**WHITE LAKE TOWNSHIP
INTER-OFFICE MEMORANDUM**

**SUBJECT: Lakepointe
Final Site Plan Re-approval
Revised Planned Development Agreement Approval**
Located on the northeast corner of Union Lake Road and Carpathian, consisting of approximately 13.32 acres. The property is currently zoned PD (Planned Development). Identified as parcel number 12-36-177-008.

RE: Lake Pointe – Final Site Plan and Final Engineering Plan –7th Review

**RE: Lake Pointe – Final Site Plan Backcheck #4
Parcel Number 12-36-177-003**

FRONT ELEVATION
 SCALE: 1/4"=1'-0"

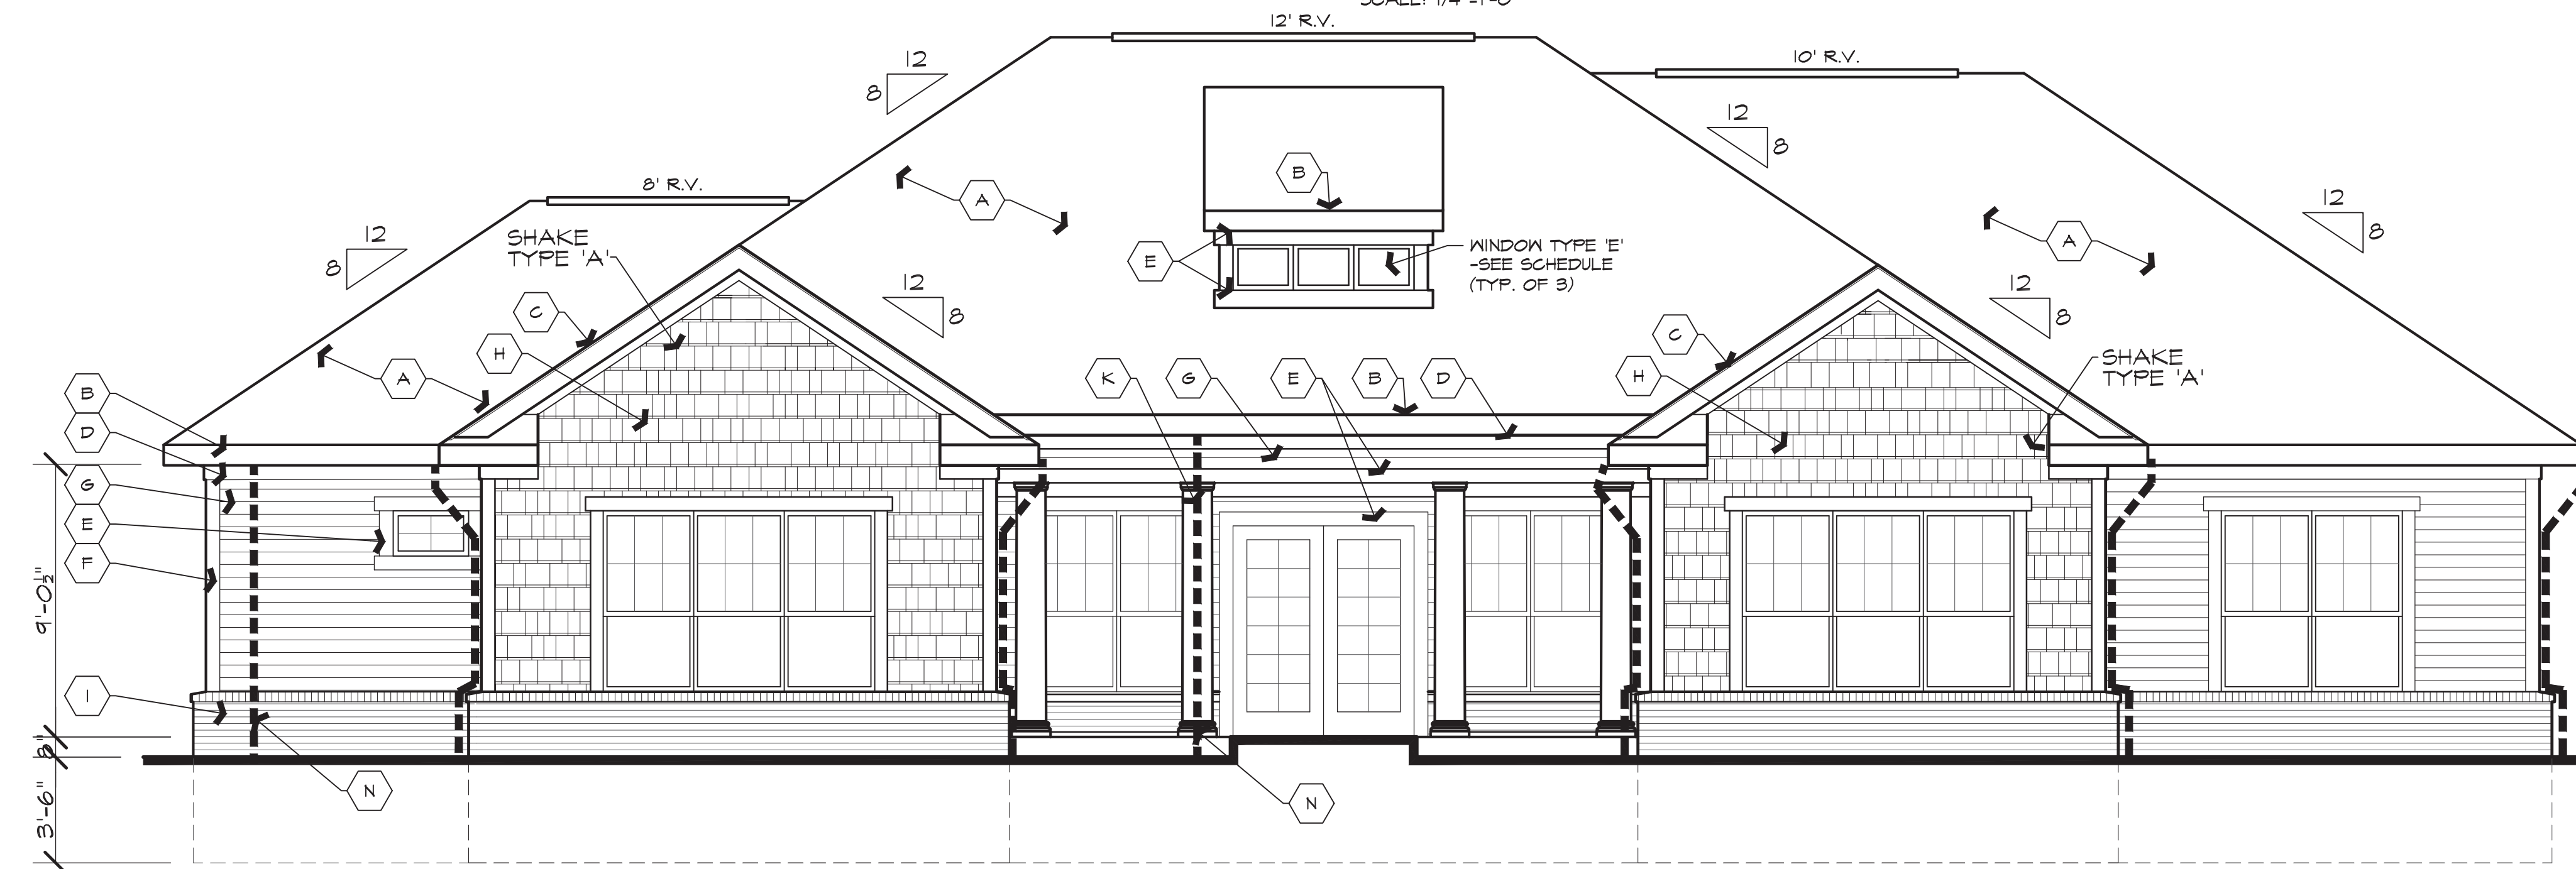
- As stated in previous correspondence (dated February 22, 2021), **elevations and building material details shall be provided for the clubhouse building.** (Comment addressed. Community building elevations have been provided).
